HYUNDAI Technical Service Bulletin	GROUP BODY ELECTRICAL	NUMBER 19-BE-016H
	DATE OCTOBER 2019	MODEL(S) ELANTRA (ADa)
SUBJECT: BLIND-SPOT RADAR REPLACEMENT, AND MOUNTING ANGLE VALIDATION

This bulletin provides the service procedure to replace the left and right Blind-Spot radar modules.

Applicable Vehicles: Certain 2019 Elantra (ADa) vehicles built from 9/04/2018 – 4/02/2019

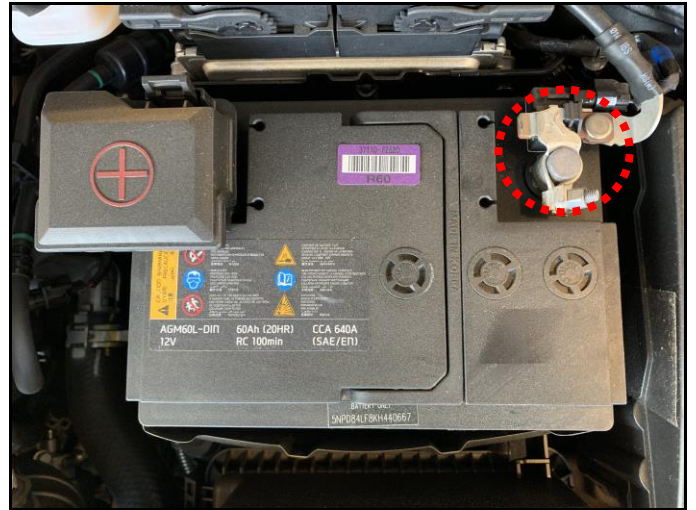
PART NAME	PART NUMBER		PART IMAGE	QTY.
	PREVIOUS	NEW		
BSD Assy - LH	99140-F3000	99140-F3001		1
BSD Assy - RH	99150-F3000	99150-F3001		1
